# SERVICE BULLETIN

ENGINE FUEL AND CONTROL — VARIABLE STATOR VANE (VSV) ACTUATOR  
— REVERSAL OF SERVICE BULLETIN V2500-ENG-73-0219 (LOW PRESSURE  
(LP) RETURN LINE RE-ROUTE PIPEWORK)

**V2500-ENG-73-0235**

The purpose of this Service Bulletin is to provide instructions for demodification, covering pressure release valve, engine pipe work, clipping points and blanking plug.

REMOVAL  
FIGURE 1, SHEET 1

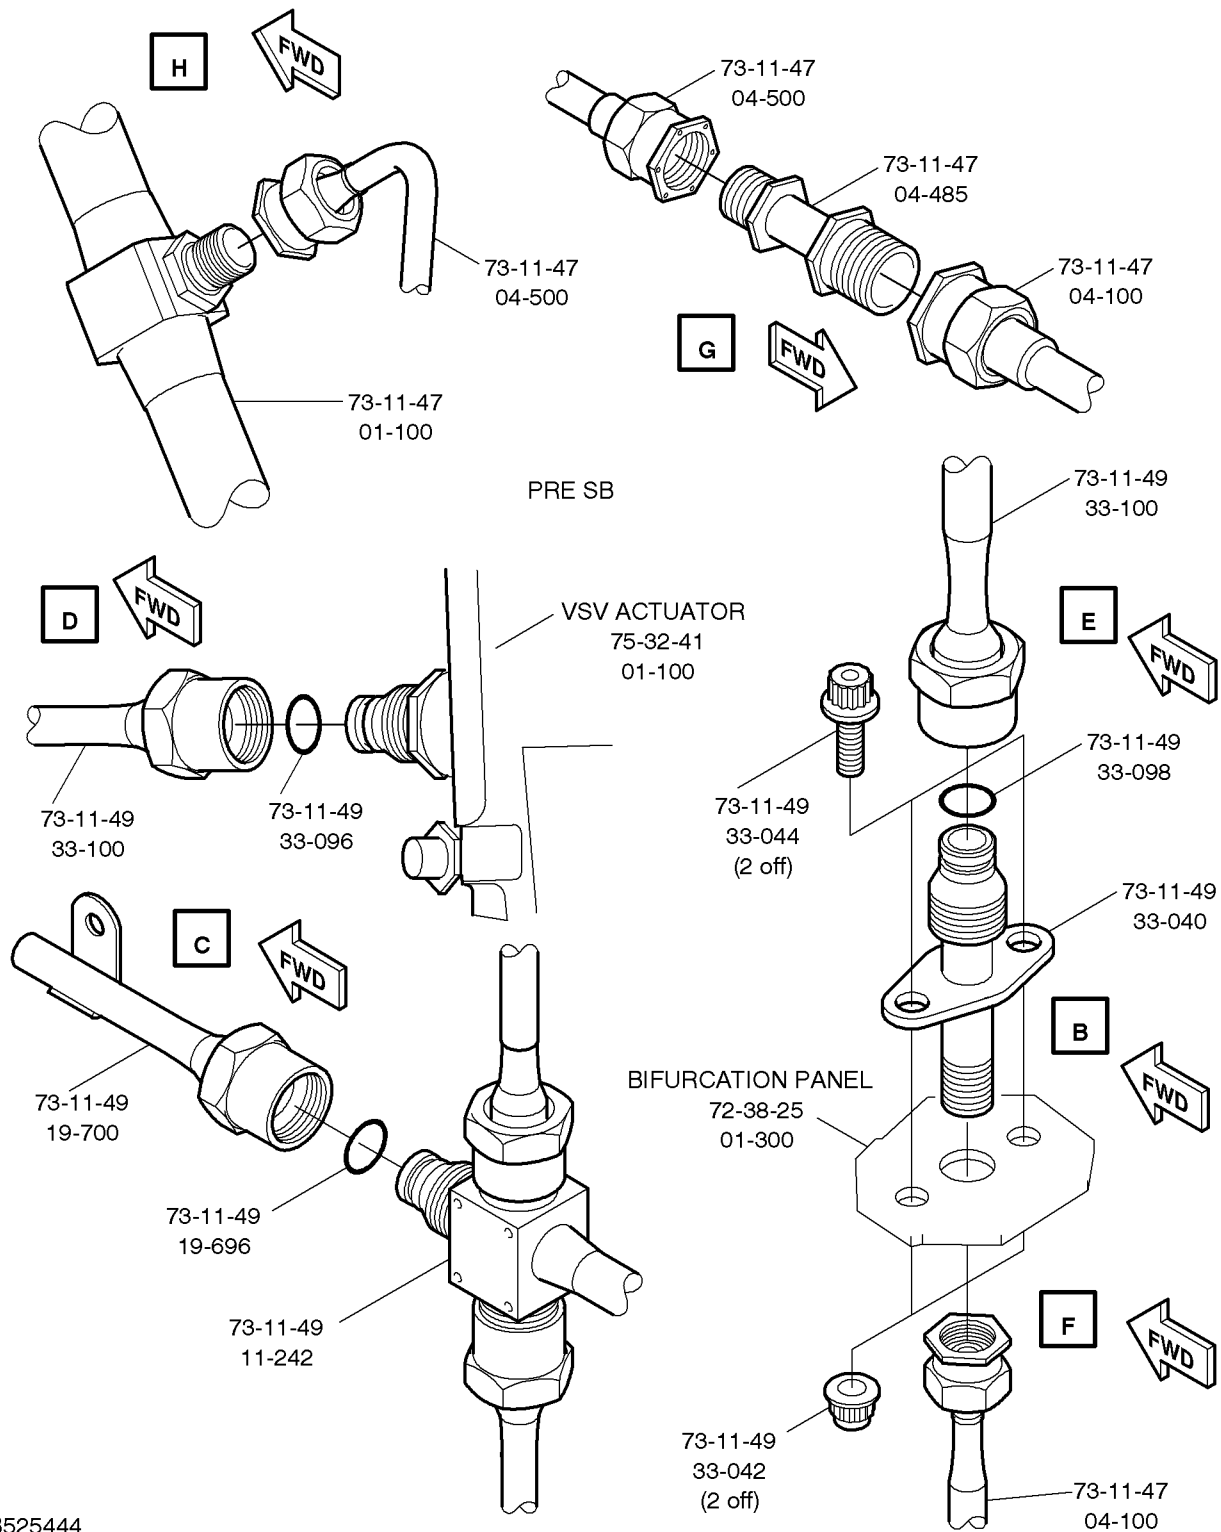
- A. Remove the two tubes (73-22-49, 05-500) and (73-11-49, 18-100) to get sufficient access for the removal of the tube (73-11-49, 19-100) and for the later installation of the two tubes (73-11-49, 19-700) and (73-11-49, 33-100), refer to Fig. 1 (sheet 1 of 7).

- C. Loosen the tube nuts that attach the tube to the VSV actuator (75-32-41, 01-100) and the four way connector (73-11-49, 11-242).
4. Remove the two new tubes (73-11-49, 33-100) and (73-11-49, 19-700) from the engine, refer to Fig. 1 (sheet 1 of 7 & sheet 2 of 7 view C, D and E).

- F. Cut and discard the lockwire that safeties tube nuts on tubes (73-11-49, 33-100) and (73-11-49, 19-700).
  - G. Remove the two tubes (73-22-49, 05-500 and 73-11-49, 18-100), refer to Fig. 1 (sheet 1 of 7), to get sufficient access for the removal of tubes (73-11-49, 19-700) and (73-11-49, 33-100) and for the later installation of the tube (73-11-49, 19-100), refer to Fig. 2 (sheet 1 of 5).

REMOVAL  
FIGURE 1, SHEET 2

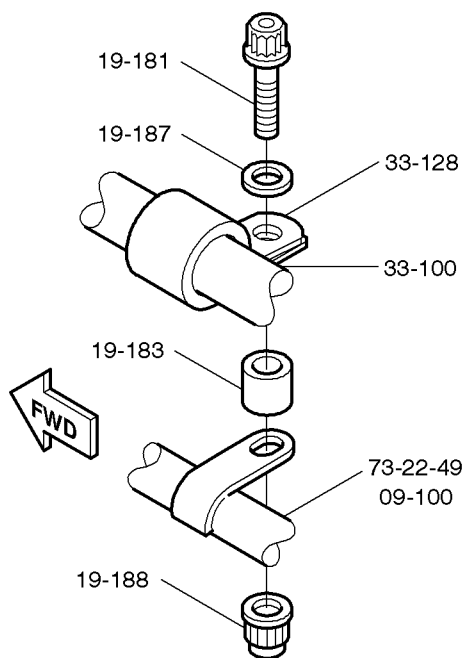
- F. Remove the new tube assembly (73-11-47, 04-500), PN 6B1353 from the PRV (73-11-47, 04-485) and from the 'T' piece on the new tube (73-11-47, 01-100), PN 745-5650-505, refer to Fig. 1 (sheet 1 of 7 & sheet 2 of 7 view G and H).

- E. Cut and discard the lockwire that safeties the tube nuts on tube (73-11-47, 04-100).
- F. Remove the PRV (73-11-47, 04-485), PN 70100-1-6 from the tube assembly (73-11-47, 04-100), refer to Fig. 1 (sheet 1 of 7 & sheet 2 of 7 view G)

- G. Remove the new tube assembly (73-11-47, 04-100), PN 6B1332 from the Adaptor (73-11-49, 33-040) on the bifurcation panel (72-38-25, 01-300), refer to Fig. 1 (sheet 2 of 7 view B and F)

8. Remove the adaptor from the bifurcation panel, refer to Fig. 1 (sheet 2 of 7 view B)
  - A. Remove the new adaptor (73-11-49, 33-040), PN 6B1329 from the bifurcation panel (72-38-25, 01-300)

- E. Torque the two nuts (72-38-25, 01-294) to 85 to 105 lbf in. (10 to 12 Nm).
10. Get access to the fuel tube assembly (73-11-47, 01-100) PN 745-5650-505 that is installed on the left side of the fan case, refer to Fig. 1 (sheet 1 of 7 & sheet 2 of 7 view H)

### REMOVAL FIGURE 1, SHEET 3

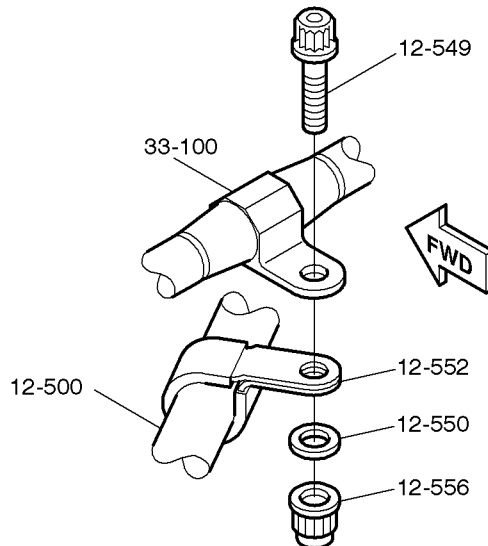
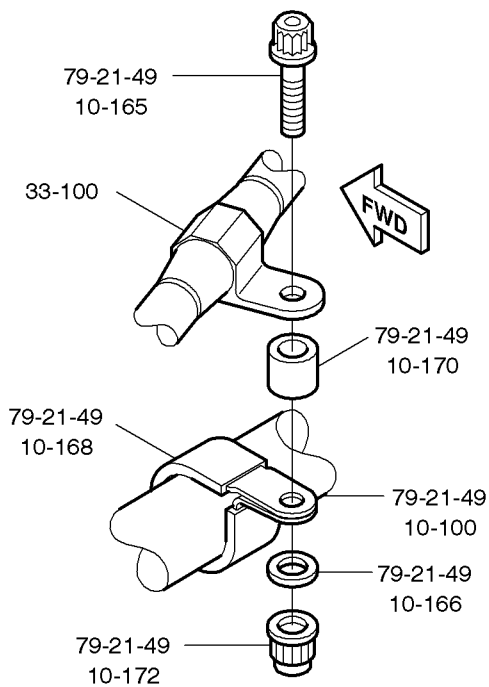
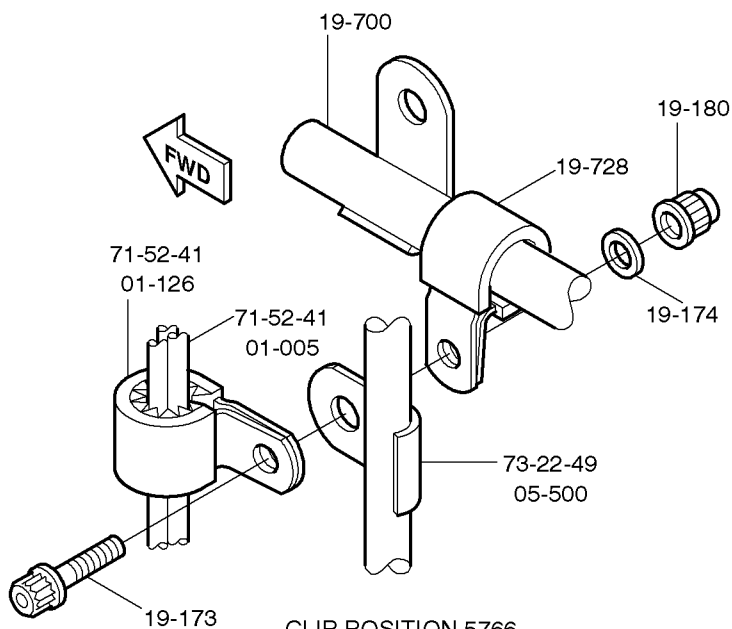
- A. At the changed clip position CP5770, refer to Fig. 1 (sheet 1 of 7 & sheet 3 of 7).
  - (1) Remove the new bolt (73-11-49, 19-181), the washer (73-11-49, 19-187), the spacer (73-11-49, 19-183) and the nut (73-11-49, 19-188) that attach the new clip (73-11-49, 33-128), to the lug on tube (73-22-49, 09-100).
- B. At the new clip position CP6158, refer to Fig. 1 (sheet 1 of 7 & sheet 3 of 7)

- (1) Remove the new bolt (73-11-49, 12-549), the new washer (73-11-49, 12-550), and new nut (73-11-49, 12-556), that attach the new clip (73-11-49, 12-552), to the lug on tube (73-11-49, 33-100).

- C. At the new clip position CP6159, refer to Fig. 1 (sheet 1 of 7 & sheet 3 of 7)
    - (1) Remove the new bolt (79-21-49, 10-165), the new spacer (79-21-49, 10-170), the new washer (79-21-49, 10-166), and new nut (79-21-49, 10-172), that attach the new clip (79-21-49, 10-168), to the lug on tube (73-11-49, 33-100).

- D. At the changed clip position CP5766, refer to Fig. 1 (sheet 1 of 7 & sheet 3 of 7)
    - (1) Remove the new bolt (73-11-49, 19-173), PN 4W0105, the washer (73-11-49, 19-174) and the nut (73-11-49, 19-180) that attach the clip (71-52-41, 01-126) and the new clip (73-11-49, 19-728), PN AS62406 to the lug on tube (73-22-49, 05-500).

## REMOVAL FIGURE 1, SHEET 4

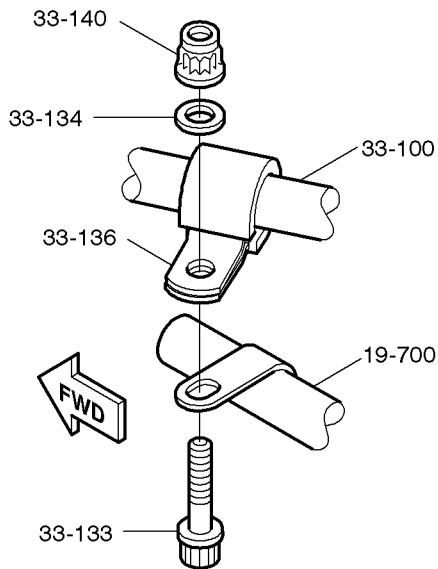
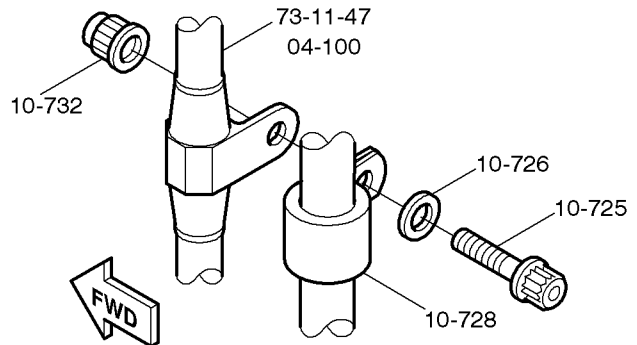
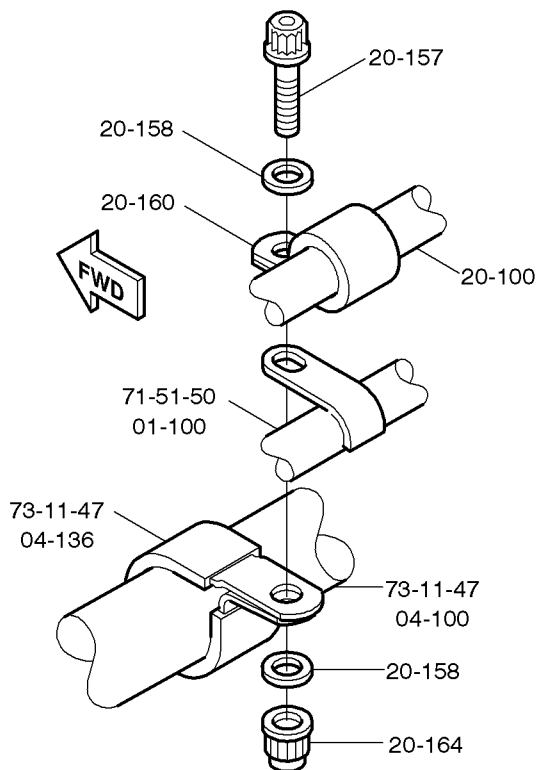
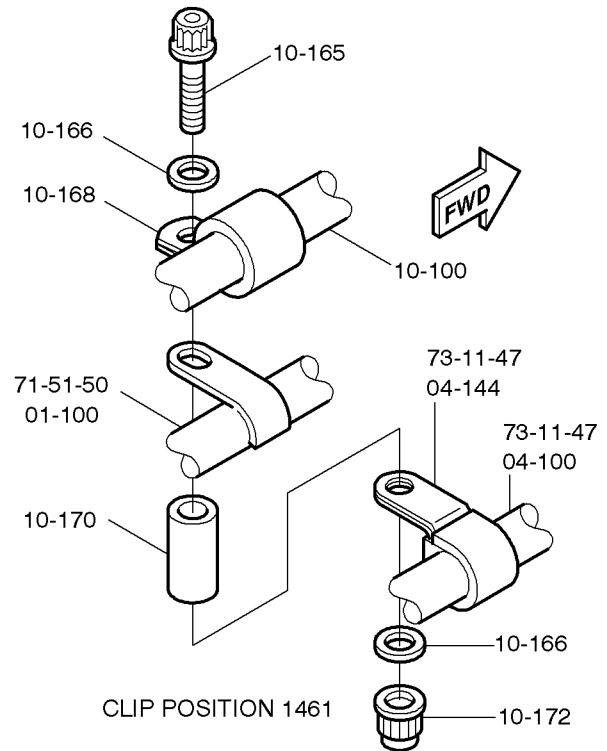
- E. At the new clip position CP6157, refer to Fig. 1 (sheet 1 of 7 & sheet 4 of 7)
    - (1) Remove the new bolt (73-11-49, 33-133), PN 4W0103, the new washer (73-11-49, 33-134), PN K8831 and the new nut (73-11-49, 33-140), PN 4W0001 that attach the new clip (73-11-49, 33-136), PN AS62406 to the lug on tube (73-11-49, 19-700).

- A. At the new clip position CP1489, refer to Fig. 1 (sheet 1 of 7 & sheet 4 of 7)
    - (1) Remove the new bolt (73-11-49, 10-725), PN 4W0104, the new washer (73-11-49, 10-726), PN K8831 and the new nut (73-11-49, 10-732), PN 4W0001 that attach the new clip (73-11-49, 10-728), PN AS62408 to the lug on tube (73-11-47, 04-100).
  - B. At the changed clip position CP1460, refer to Fig. 1 (sheet 1 of 7 & sheet 4 of 7)
    - (1) Remove the new bolt (73-11-49, 20-157), PN 4W0104, the two new Washers (73-11-49, 20-158), PN K8831 and the nut (73-11-49, 20-164) that attach the clip (73-11-49, 20-160) and the clip (73-11-47, 04-136) to the lug on tube (71-51-50, 01-100).
  - C. At the changed clip position CP1461, refer to Fig. 1 (sheet 1 of 7 & sheet 4 of 7)

- (1) Remove the new bolt (73-11-49, 10-165), PN 4W0114, the two new Washers (73-11-49, 10-166), PN K8831, the new spacer (73-11-49, 10-170), PN UP10480 and the nut (73-11-49, 10-172) that attach the clip (73-11-49, 10-168) and the new clip (73-11-47, 04-144), PN AS62406 to the lug on tube (71-51-50, 01-100).

## REMOVAL FIGURE 1, SHEET 5

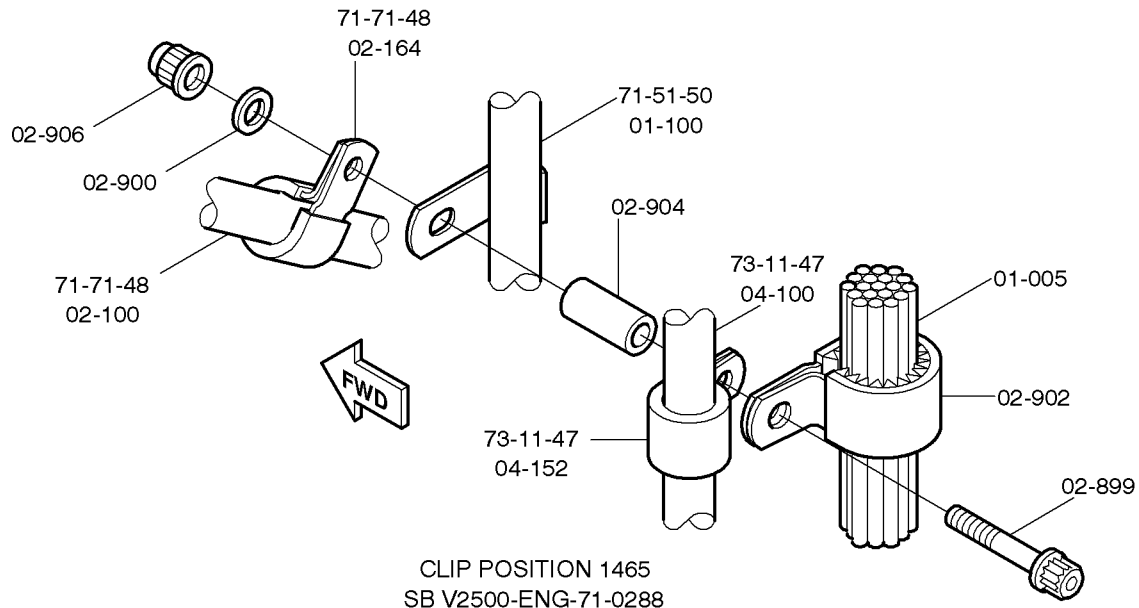
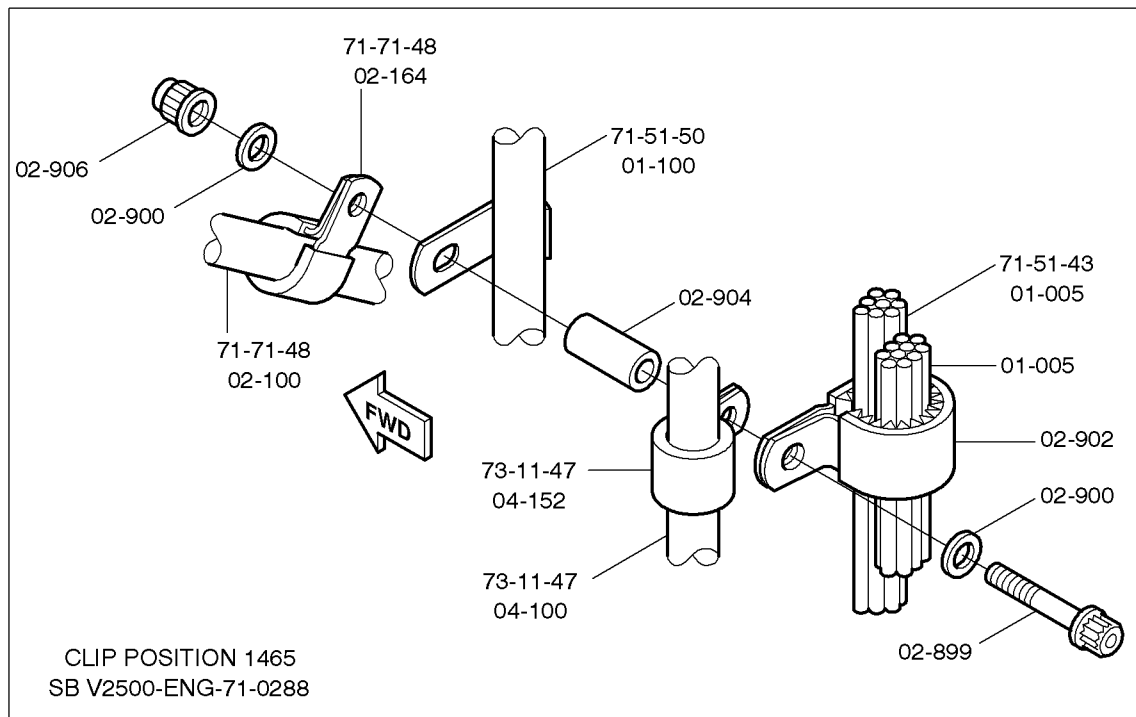
- D. At the changed clip position CP1465, refer to Fig. 1 (sheet 1 of 7 & sheet 5 of 7)
  - (1) Remove the new bolt (71-51-41, 02-899), PN 4W0116, the washer (71-51-41, 02-900), the spacer (71-51-41, 02-904) and the nut (71-51-41, 02-906) that attach the clips (71-51-41, 02-902 and 71-71-48, 02-164) and the new clip (73-11-47, 04-152), PN AS62406 to the lug on tube (71-51-50, 01-100).

### REMOVAL FIGURE 1, SHEET 6

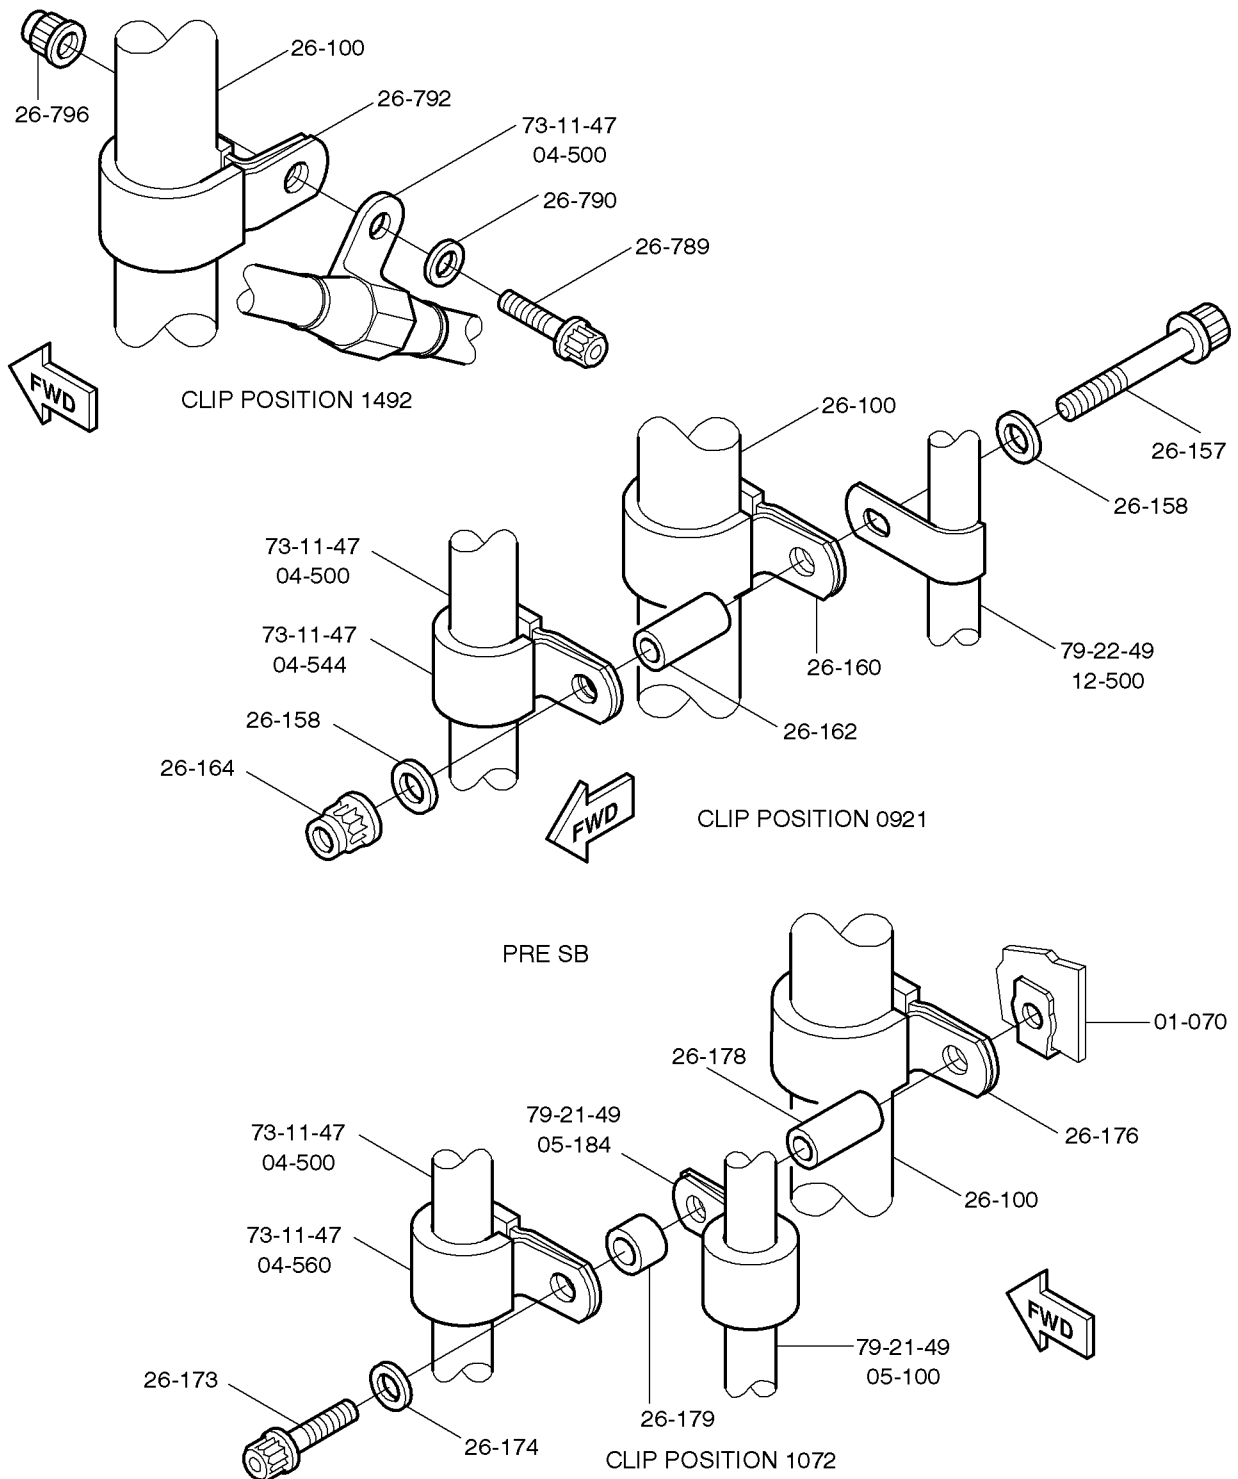
- A. Cut and discard the lockwire that safeties the tube nuts on tube (73-11-47, 04-500).
  - B. At the new clip position CP1492, refer to Fig. 1 (sheet 1 of 7 & sheet 6 of 7)

- (1) Remove the new bolt (73-11-49, 26-789), PN 4W0104, the new washer (73-11-49, 26-790), PN K8831 and the new nut (73-11-49, 26-796), PN 4W0001 that attach the new clip (73-11-49, 26-792), PN AS62416 to the bracket on tube (73-11-47, 04-500).

- C. At the changed clip position CP0921, refer to Fig. 1 (sheet 1 of 7 & sheet 6 of 7)
    - (1) Remove the new bolt (73-11-49, 26-157), PN 4W0118, the two new washers (73-11-49, 26-158), PN K8831, the new spacer (73-11-49, 26-162), PN UP10481 and the nut (73-11-49, 26-164) that attach the clip (73-11-49, 26-160) and the new clip (73-11-47, 04-544), PN AS62406 to the lug on tube (79-22-49, 12-500).

- E. At the changed clip position CP1072, refer to Fig. 1 (sheet 1 of 7 & sheet 6 of 7)

- (1) Remove the new bolt (73-11-49, 26-173), PN 4W0124, the new spacer (73-11-49, 26-179), PN UP10479 and the spacer (73-11-49, 26-178) that attach the new clip (73-11-47, 04-560), PN AS62406, the clip (79-21-49, 05-184) and the new clip (73-11-49, 26-176), PN AS62416 to the bracket (24-21-49, 01-070).
